SITE DEVELOPMENT PLAN
MONUMENT STEEL STRUCTURES
 SITE LANDSCAPE PLAN
 18910 BASE CAMP ROAD
 MONUMENT, COLORADO

PCD FILE NO. RPR1919

SITE DEVELOPMENT PLAN
MONUMENT STEEL STRUCTURES
LANDSCAPE DETAILS
18910 BASE CAMP ROAD
MONUMENT, COLORADO

SITE LANDSCAPE PLAN

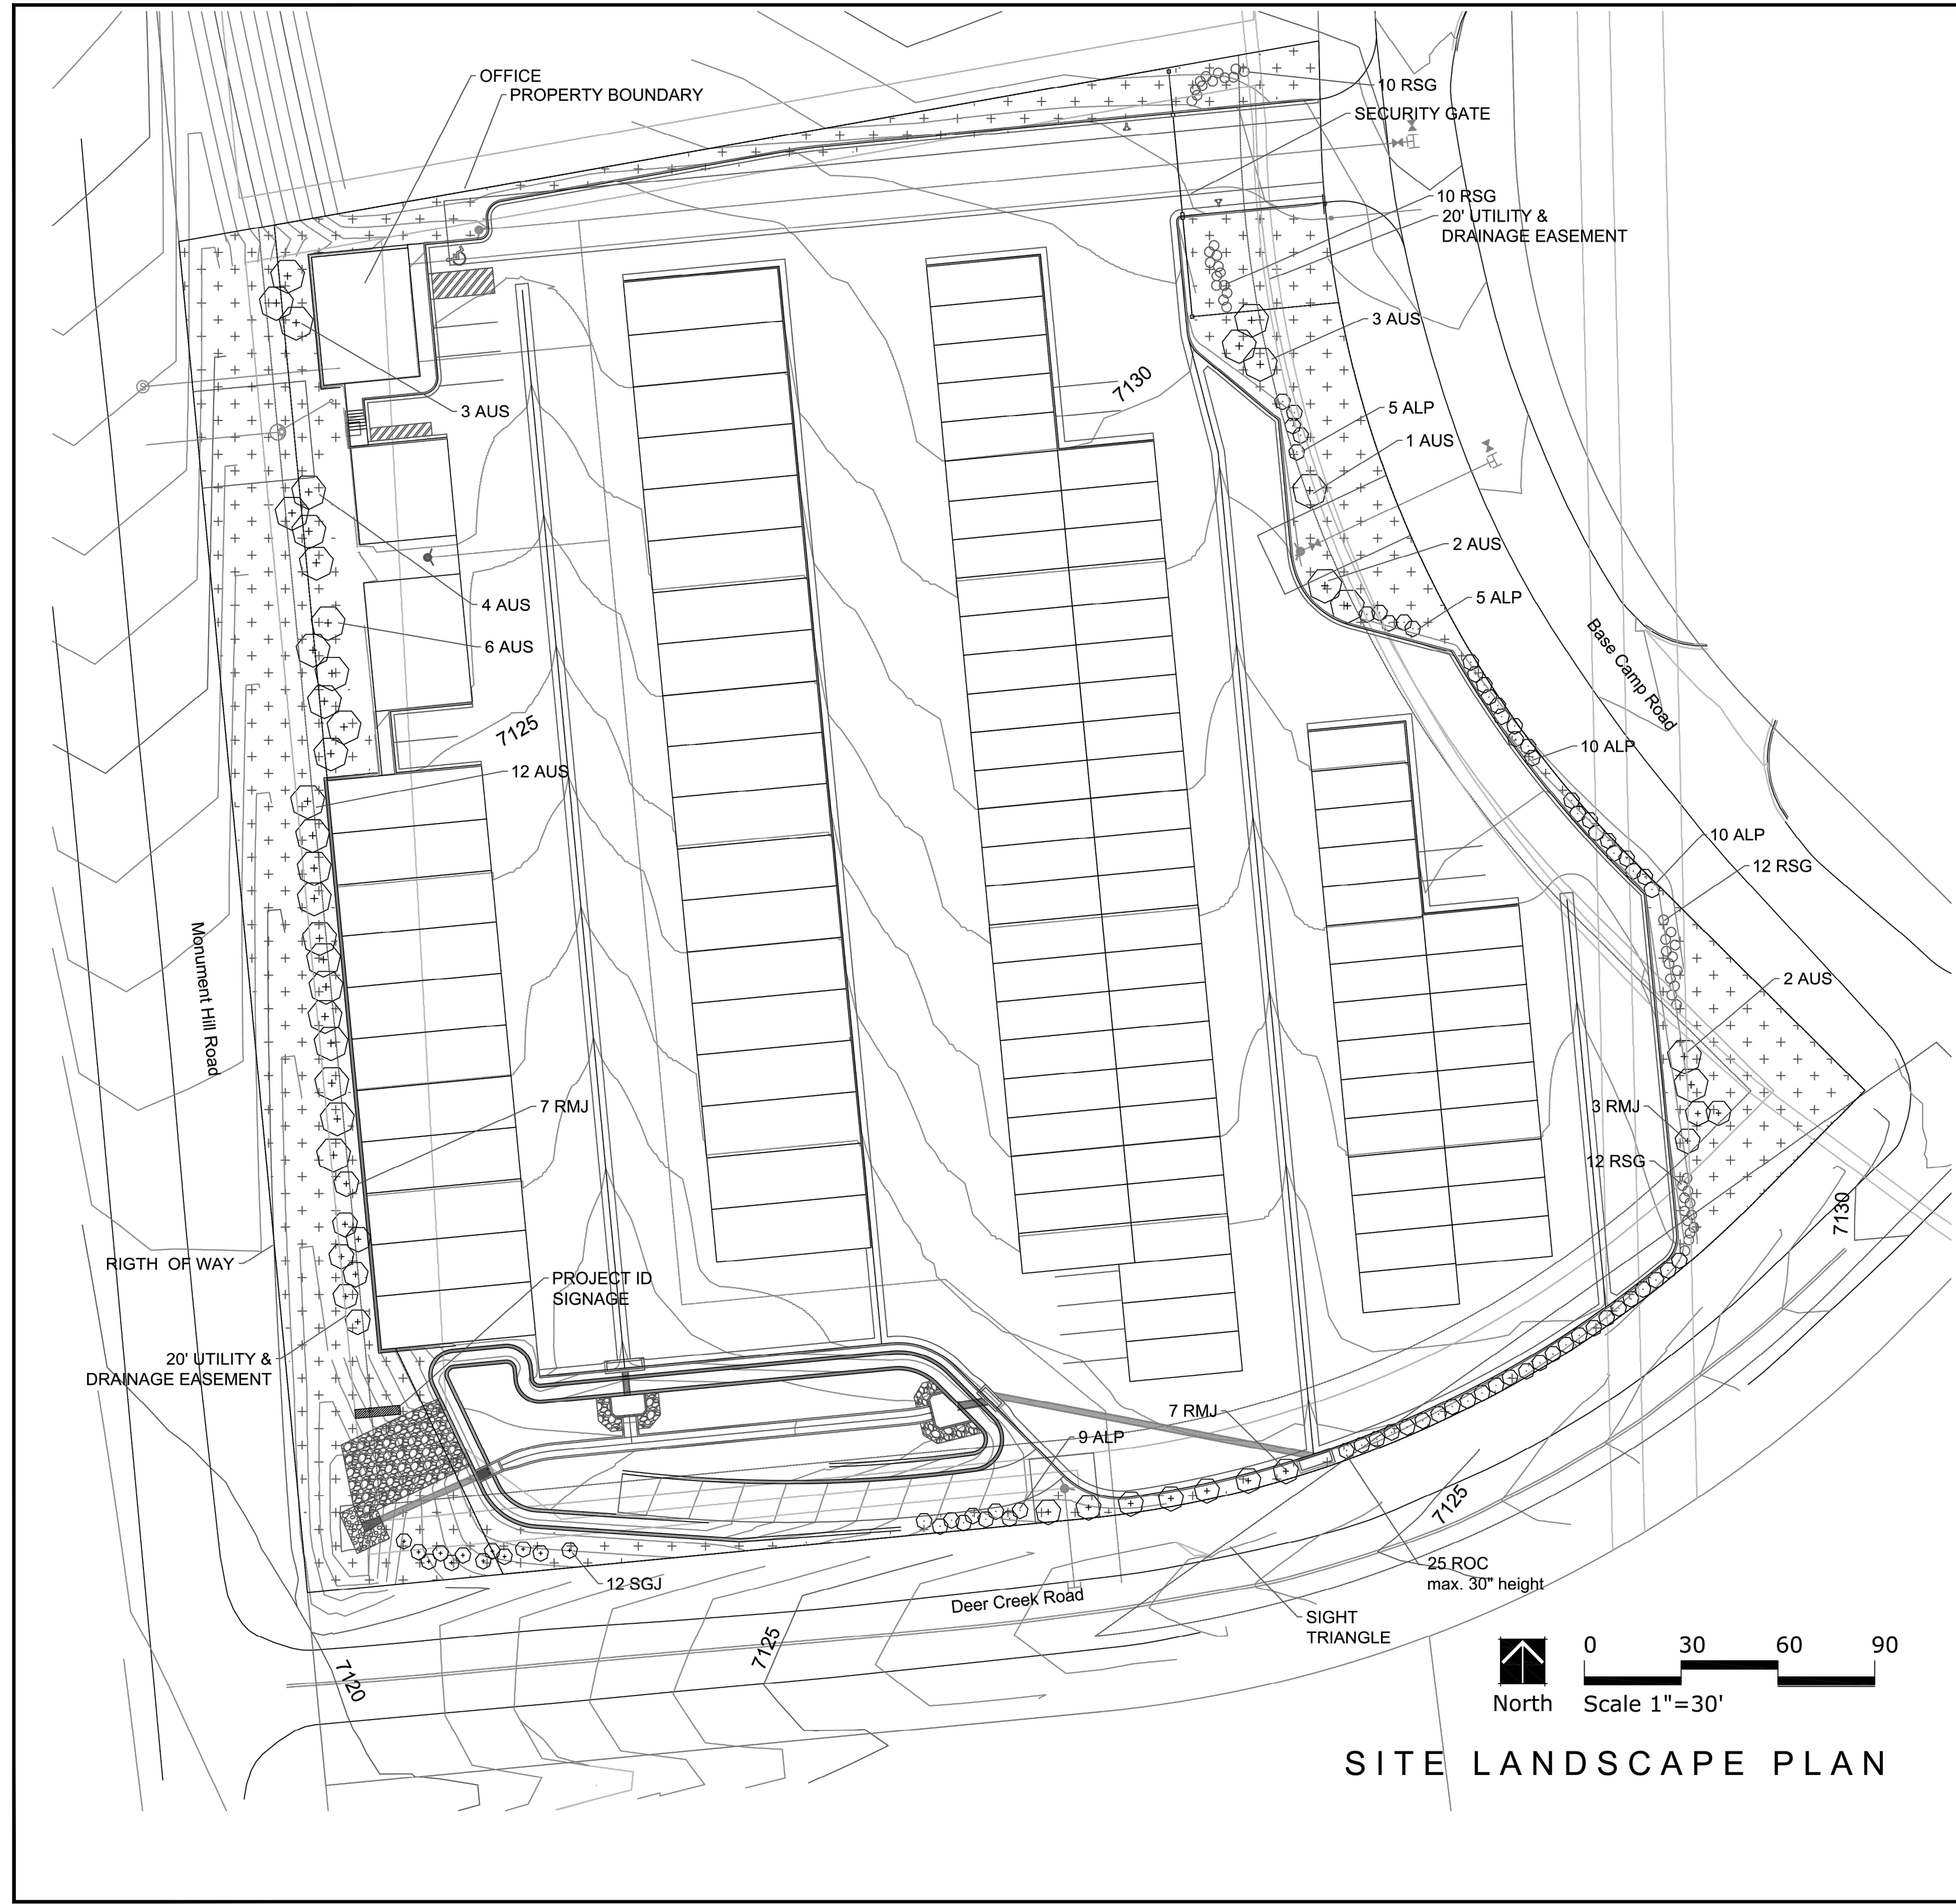
Update all
